**YPSILANTI
TOWNSHIP**
— PLANNING & ZONING DEPARTMENT —

Preliminary Site Plan and Special Use Review For Ypsilanti Township, Michigan

Applicant:	UPH Ypsilanti Property LLC (Represented by Charles Paisley)
Project Name:	Culver's Restaurant and Drive-Through
Plan Date:	July 18, 2024
Latest Revision:	December 20, 2024
Location:	1410 Huron St. (On west side of South Huron Street, just north of Aldi site at Brinker Way)
Zoning:	FB, Form Based District – Town Center
Action Requested:	Preliminary Site Plan and Special Use Approval

SITE LAYOUT PLAN
CULVERS - YPSILANTI
PART OF SECTION 16, T3S, R7E
YPSILANTI TOWNSHIP, WASHTENAW COUNTY, MICHIGAN

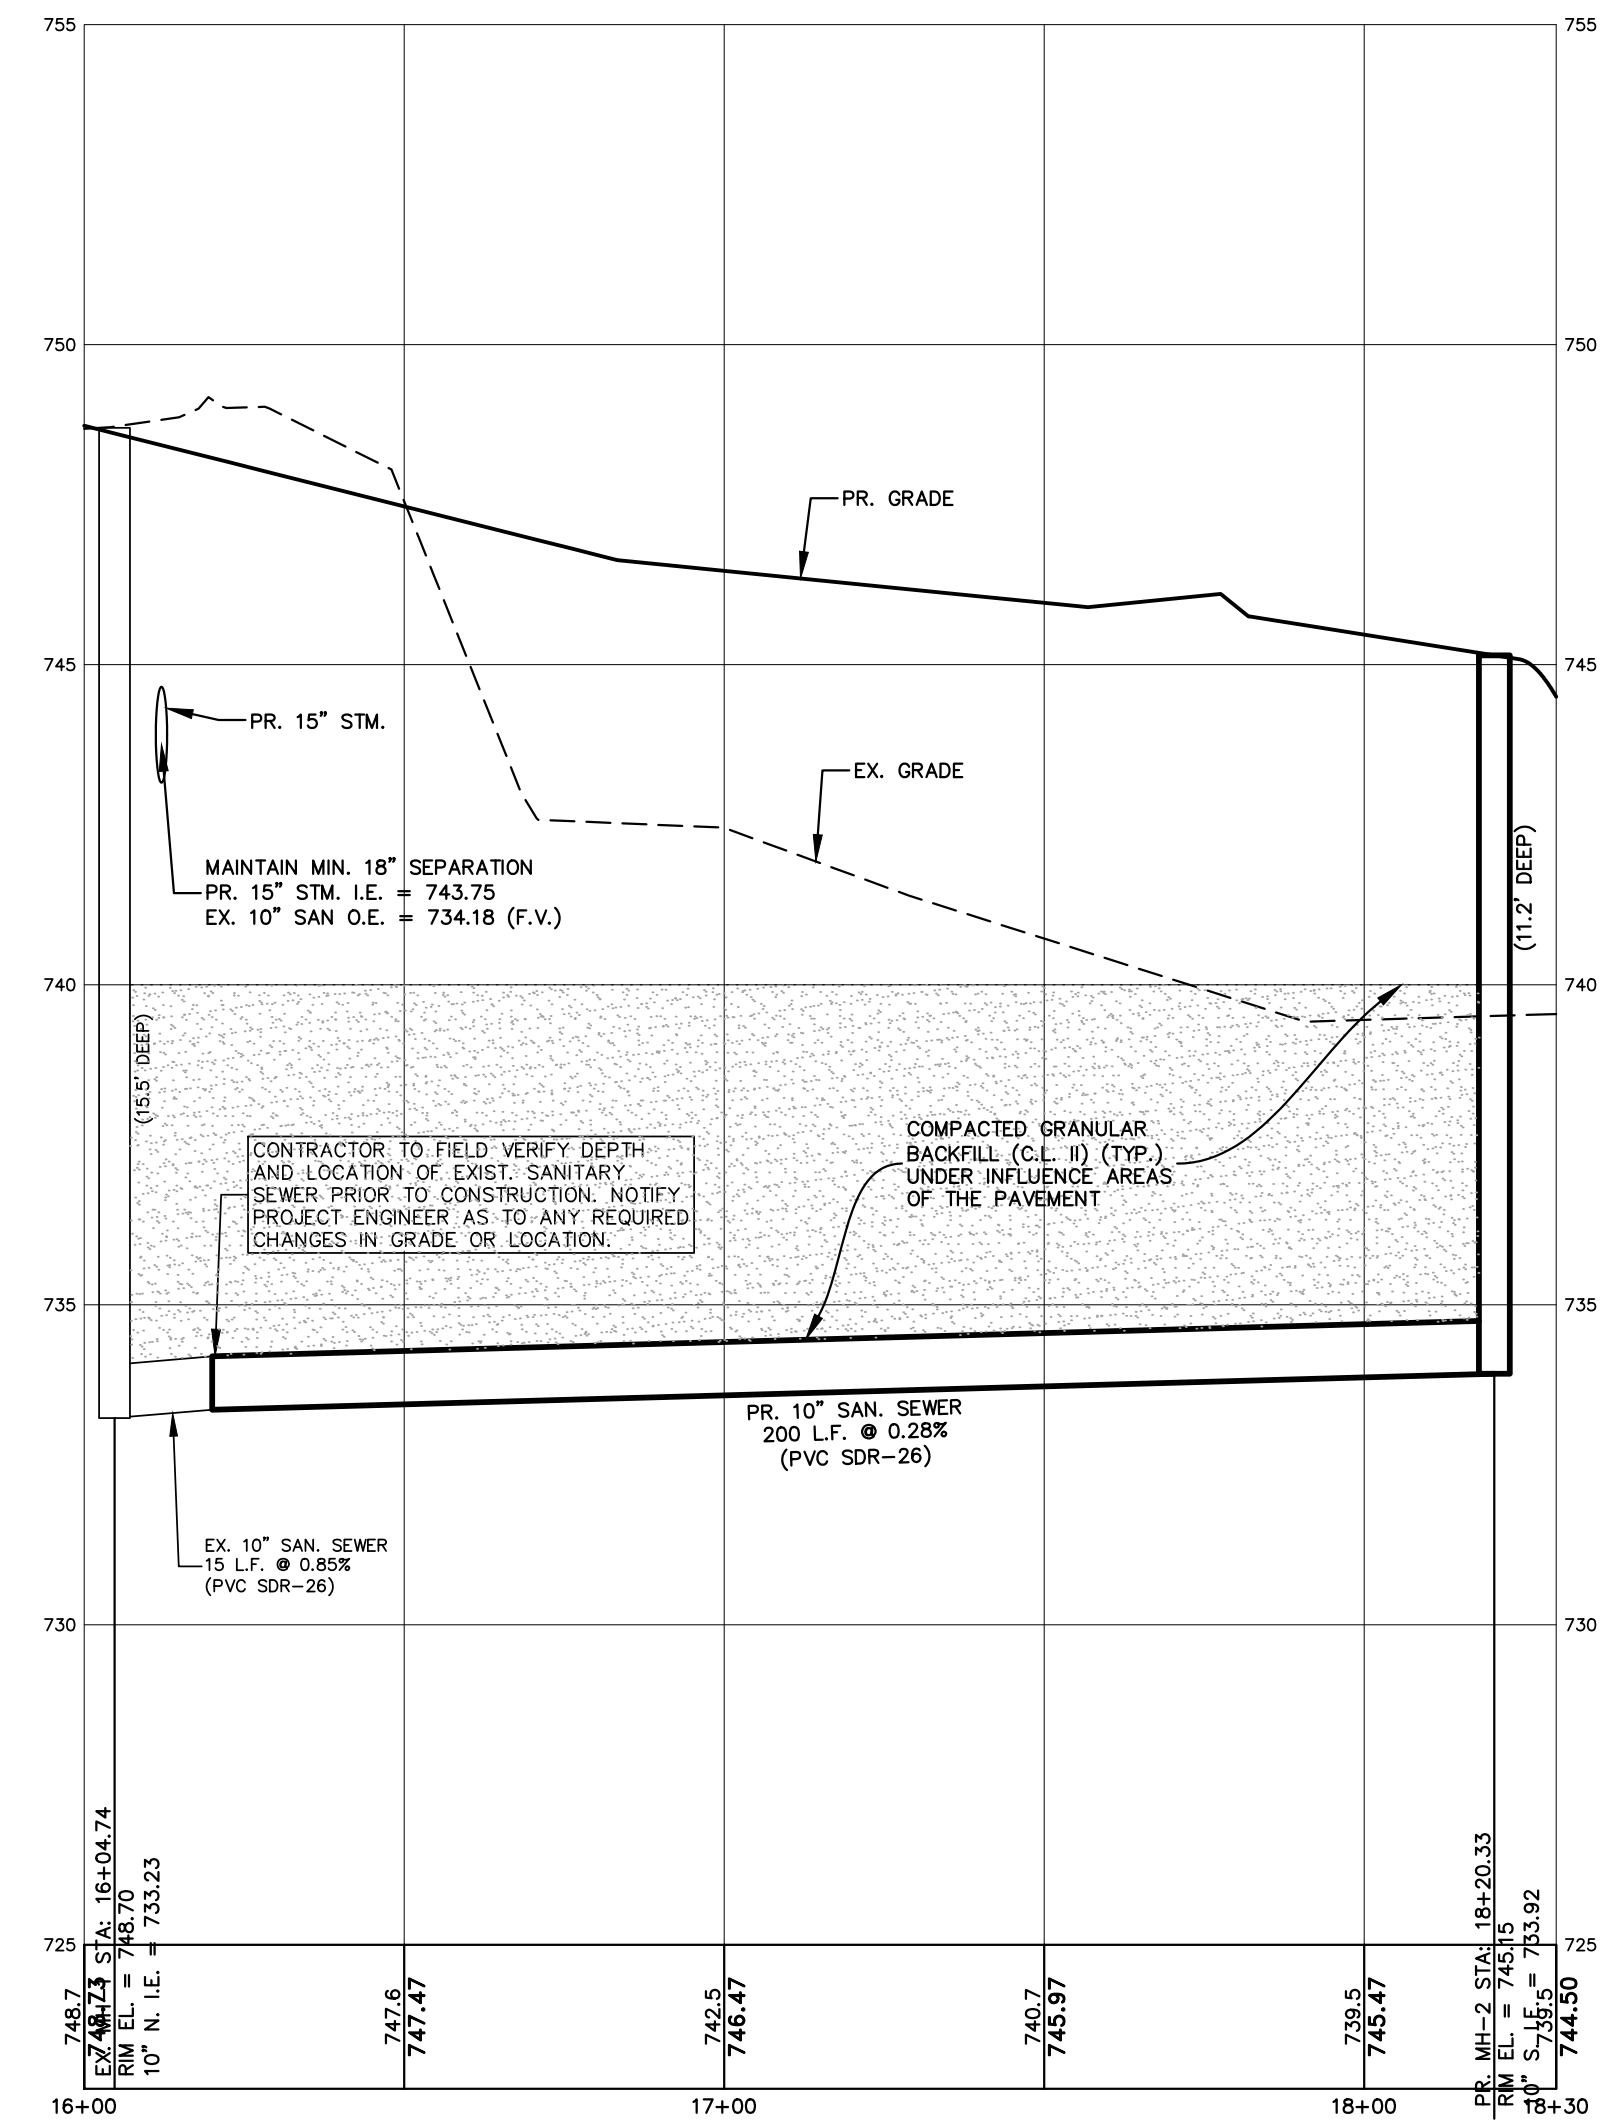
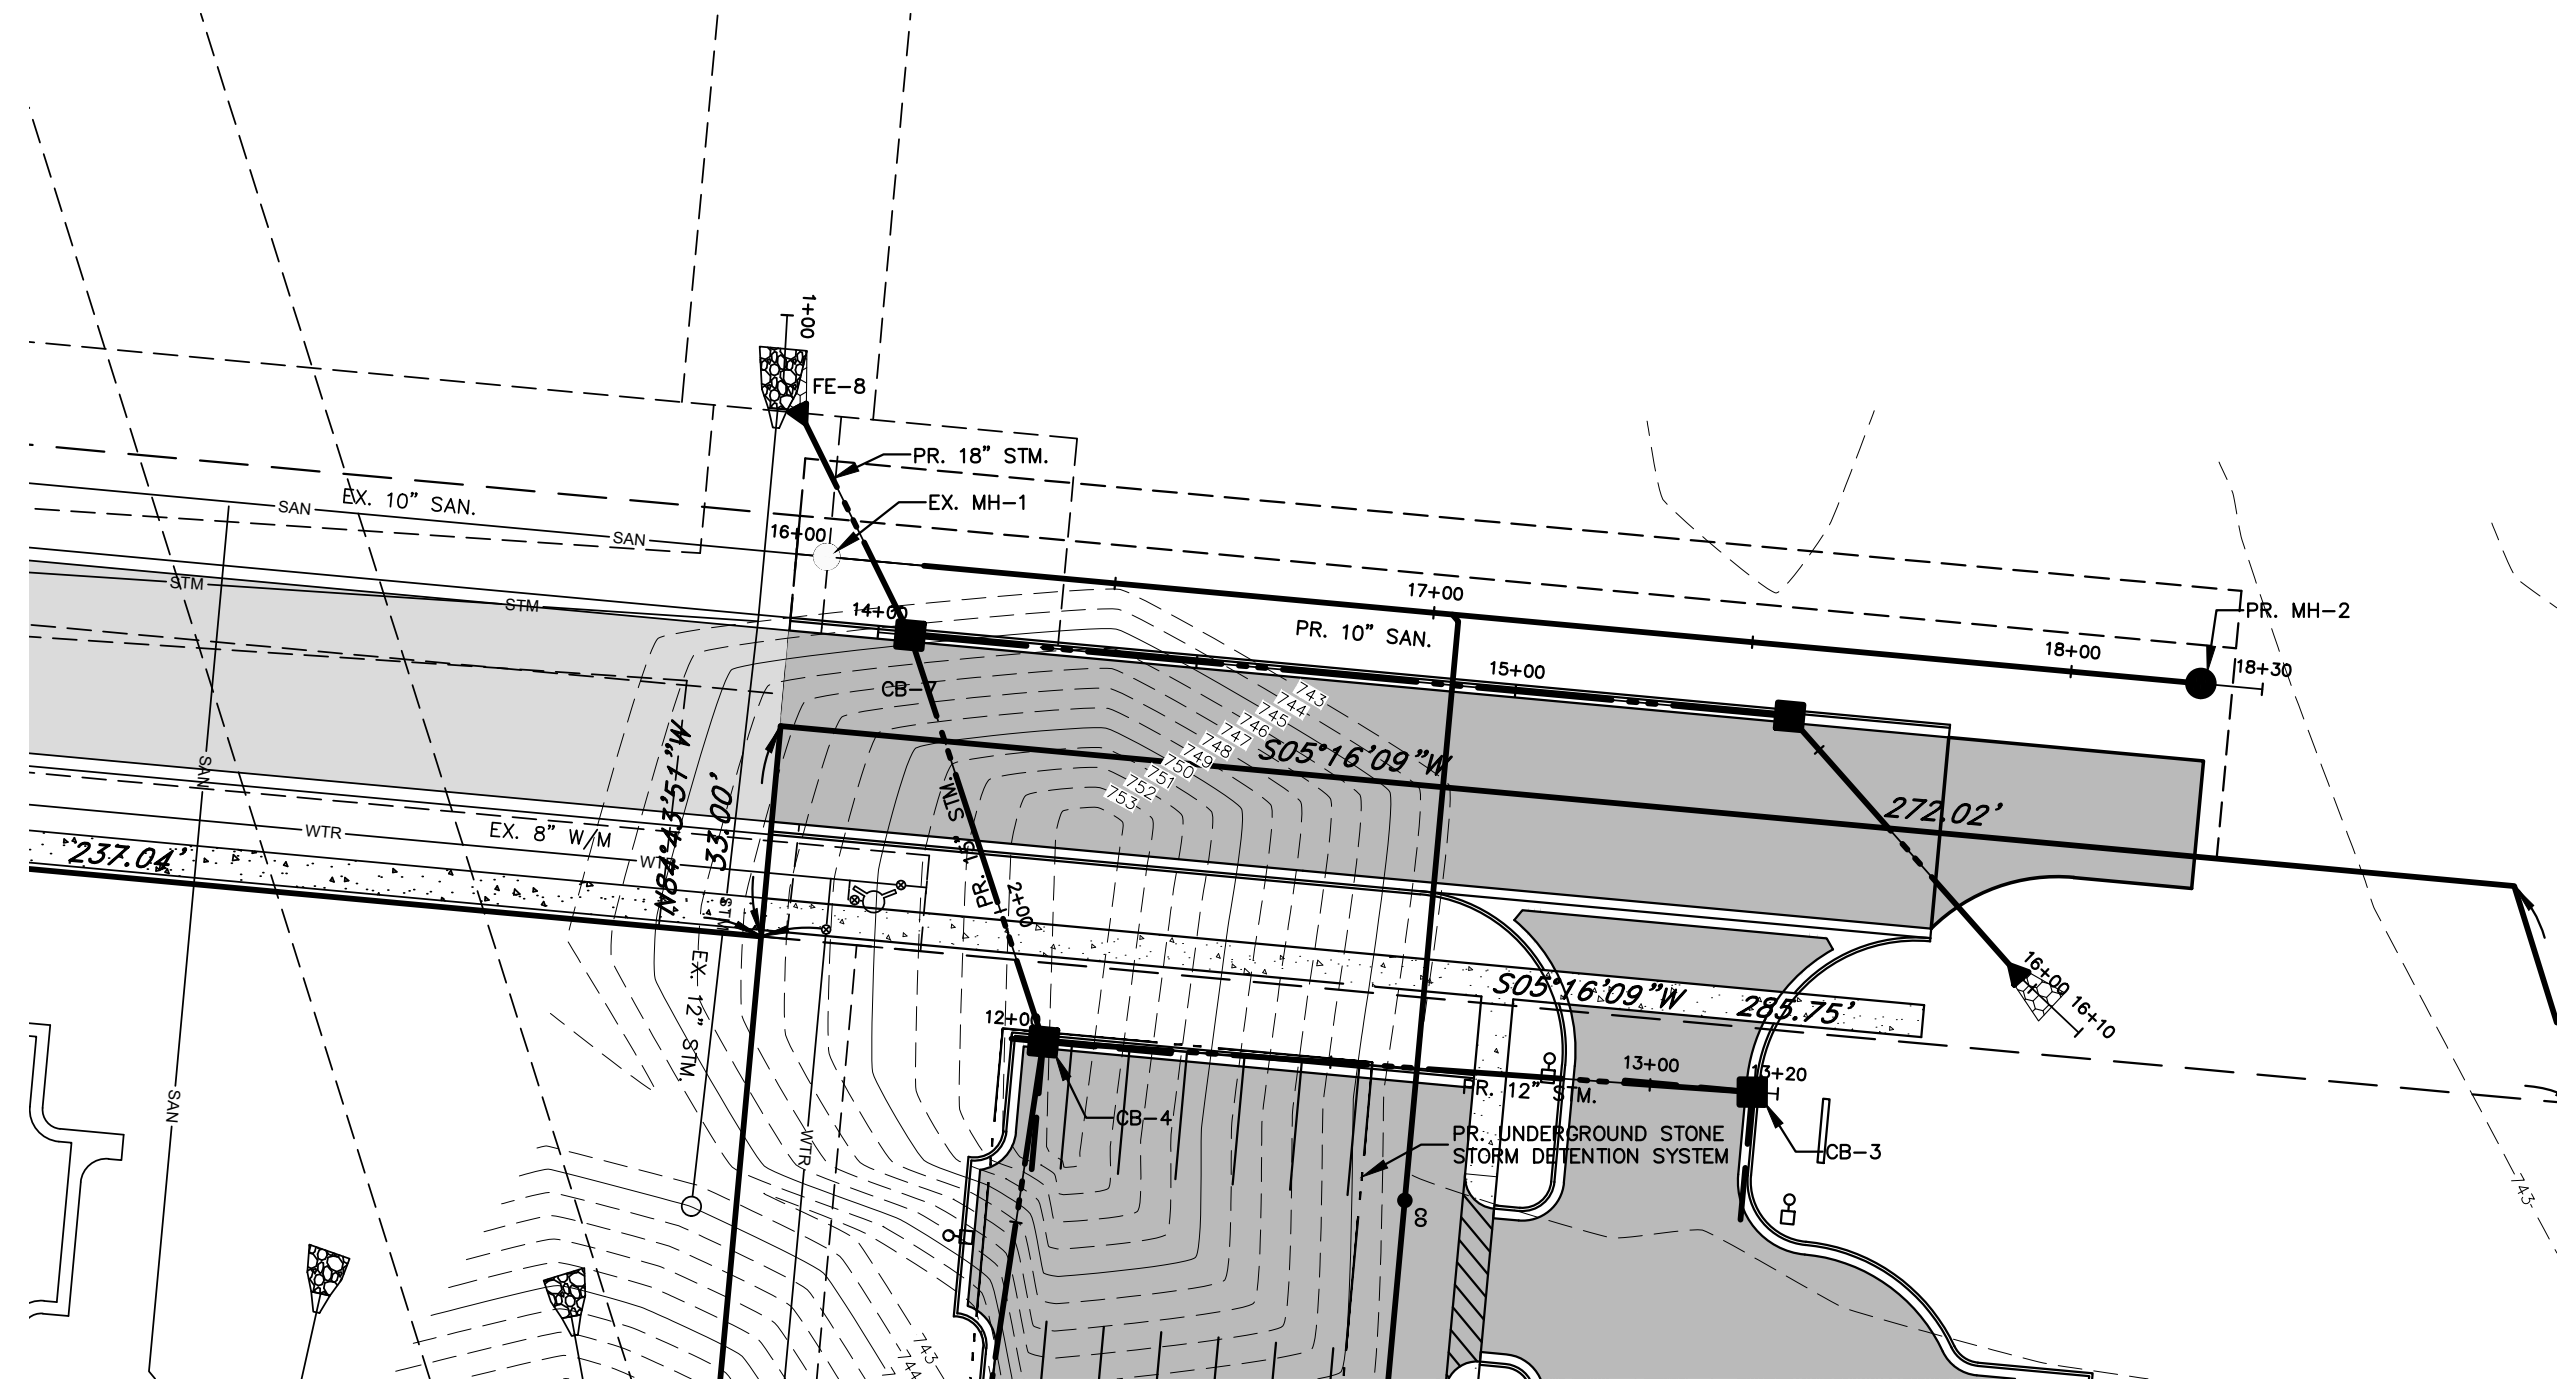
9. The applicant shall verify the rim/invert elevations and the name of the proposed sanitary sewer manhole on to the northwest as there appears to be discrepancies between the plan view (Sheet C-103) and the profile view (Sheet C-202).

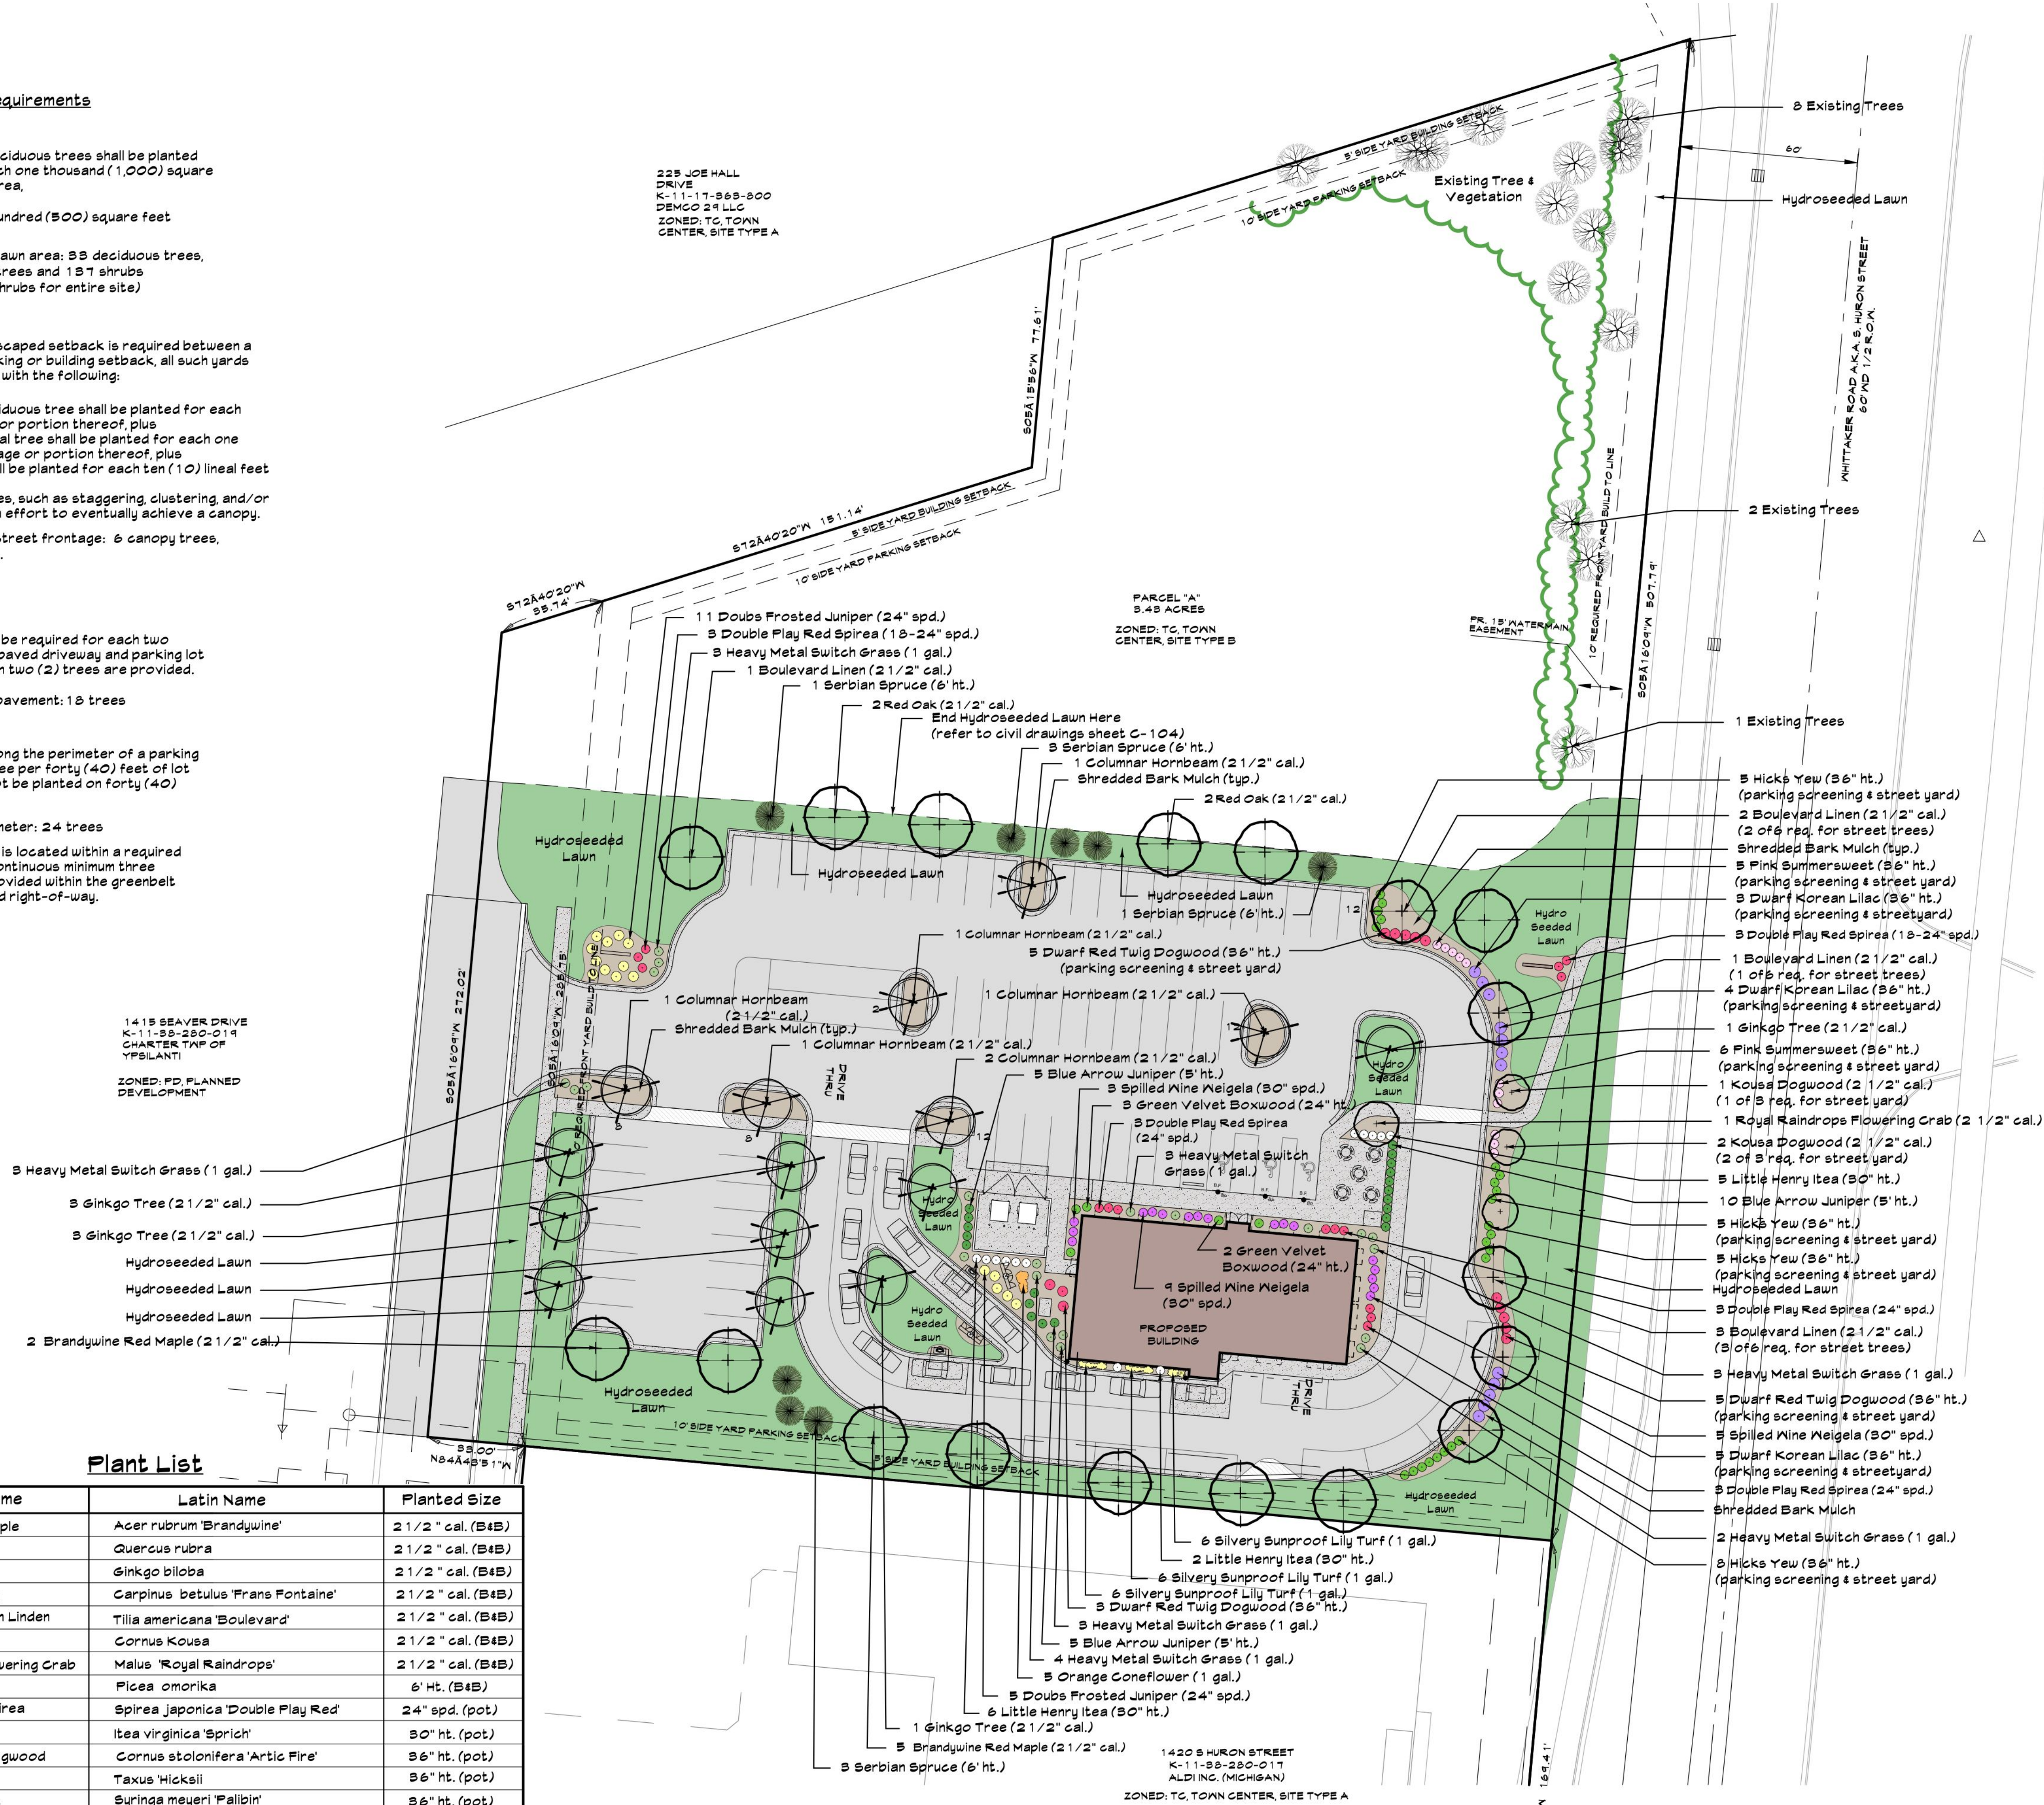
- 2) Also, the proposed plant material sizes listed in our previous review were adjusted to meet ordinance requirements. (Note that the Plant List should update the size of the 'Spilled Wine' Weigela to be a minimum size of 30-inches.)

D. Irrigation: The ordinance requires that the Landscape Plan include a note stating that the site will have an underground irrigation system for all landscaped areas. This is provided in Note #8 on Sheet L-1.

7. The applicant shall provide the hydraulic grade line on all storm sewer profiles.
8. The applicant shall overlay all existing and proposed utilities on the Landscape Plan (Sheet L-1) and note that trees shall not be placed directly above any utilities.
